PRODUCT CHANGE NOTIFICATION

#PCN-MI-3W6E-16

Business Unit	Product Line Code	Type of Change	Action	Date of issue
MI	BG4	Electrical	Notify Distributors and Field	1/11/2016

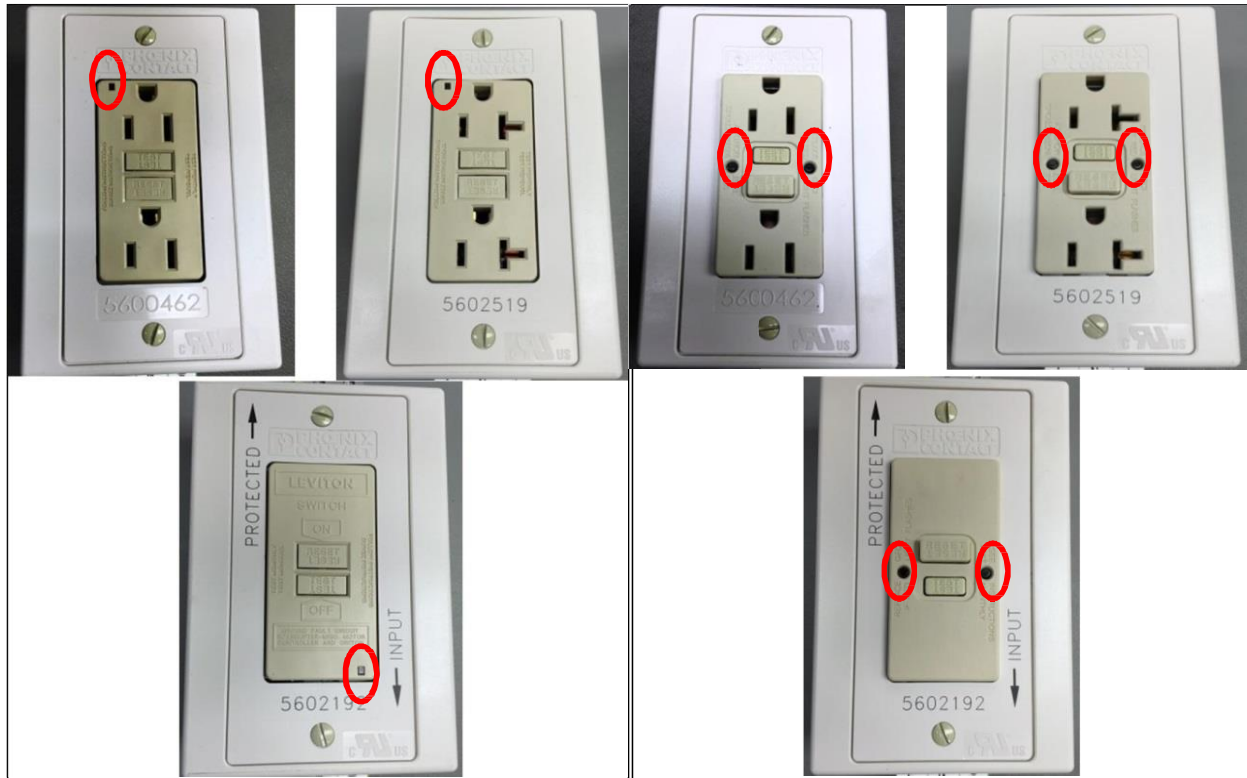
UL943 was revised to ensure safe operation and proper wiring of GFI receptacles. GFI receptacles will contain a self-test or auto-monitoring circuit that tests the ability of the GFI to detect a ground fault. If self-test detects a problem, the GFI must deny power and provide visual indication of fault. Also, the GFI must detect when the line and load are reverse-wired and deny power to the face.

The new versions will contain two separate LEDs instead of one.
